**STATE OF RHODE ISLAND AND PROVIDENCE PLANTATIONS
ENERGY FACILITY SITING BOARD**

In re: The Narragansett Electric :
Company d/b/a National Grid : **Docket No. SB-2012-01**
Interstate Reliability Project :

National Grid's Responses to the
EFSB's 1st Set of Data Requests

REQUEST EFSB 1-7:

345KV
DAVIT ARM W/ RESTRAINED
INSULATORS

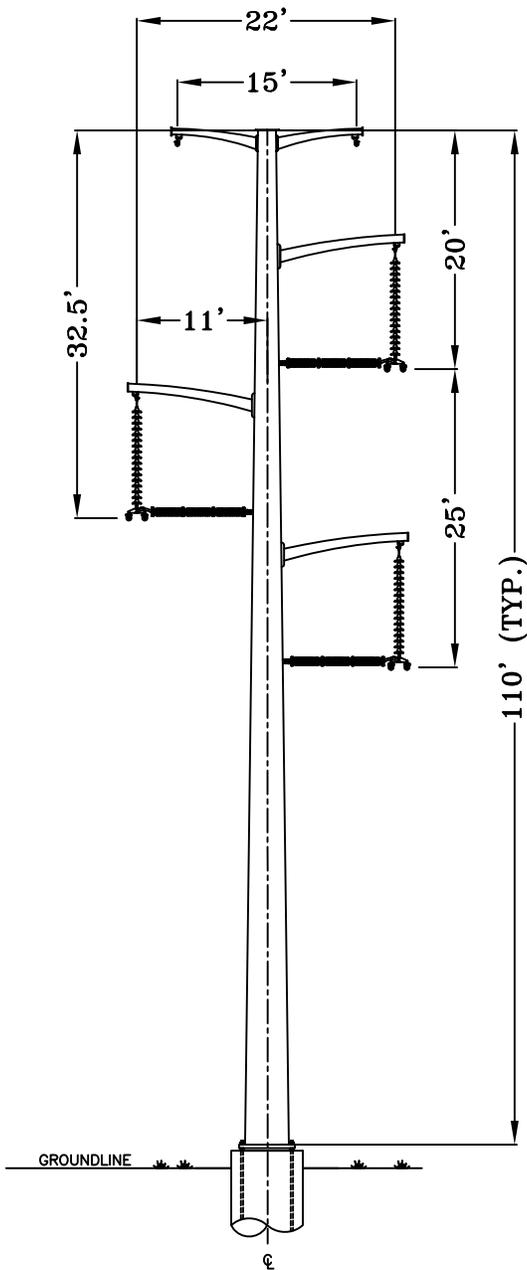
In regards to the overhead alternatives detailed in Section 5.6 (pages 5-29 through 5-32), please provide an explanation and comparison of project costs between the use of davit-arm structures and double-circuit davit arm structures versus the proposed H-frame structures. If possible, please provide these cost comparisons in the same format as utilized for Table 4-3 (page 4-22).

366 Line from the MA/RI state line to West Farnum Substation. Replacement of the proposed H-frame structures with davit arm structures (see Attachment 1) would result in a reduction of approximately 8 acres of tree clearing and elimination of the need to perform trimming along the ROW edge where clearing is not otherwise required. However, structures would average 25 feet taller than the H-frame structures (see Note 1), and environmental impacts along the ROW would be greater due to the need for more robust access roads to support the significant increase in concrete foundation installations. The estimated 366 line cost would increase from \$26.8M to \$31.5M.
